From: Sarah Schafer
Sent: Thursday, June 30, 2016 11:42 AM
To: 'Renee Strand'
Subject: RE: The Fowler - Roof Screen

Attached is a diagram of the roof screen we are proposing to remove from the Fowler.

PROPOSED SECTION
OF ROOF SCREEN TO
REMOVE

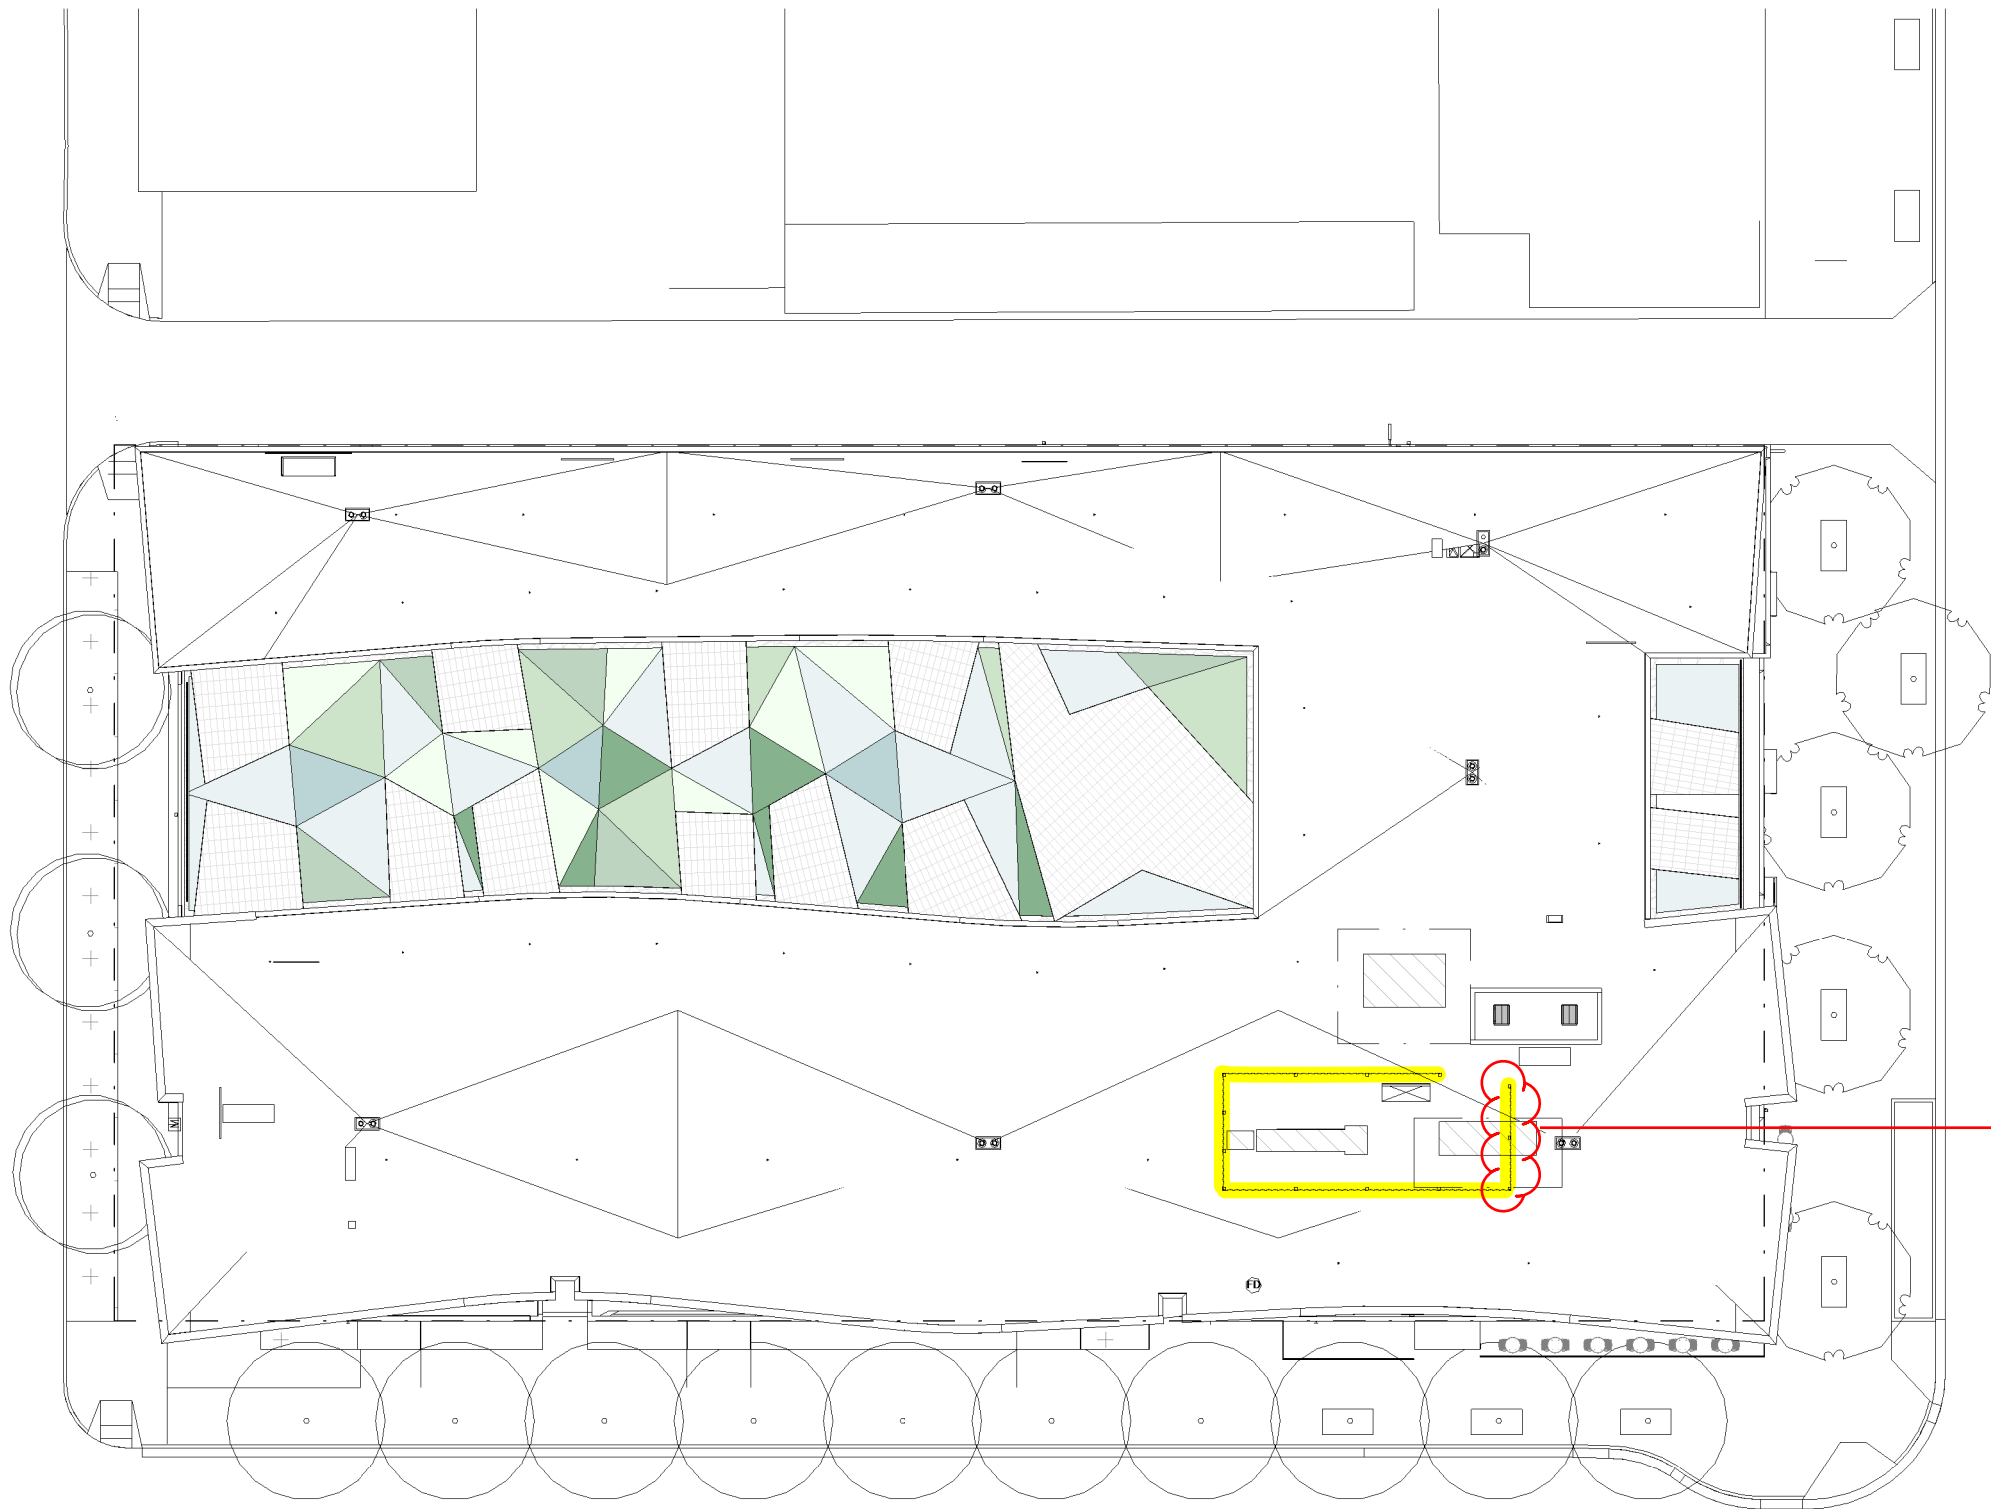
Because of changes in the air handling unit sizes they will no longer be visible from across the street – we've attached model views to illustrate.

The unit extends 5'-7" above to top of parapet – however it is not visible from the sidewalk across the street, which was the criteria set up for all the units on the building early on.

We are comfortable with the removal of the mechanical screen at the shown location. I will add a copy of this e-mail and the plan to the file to track the change.
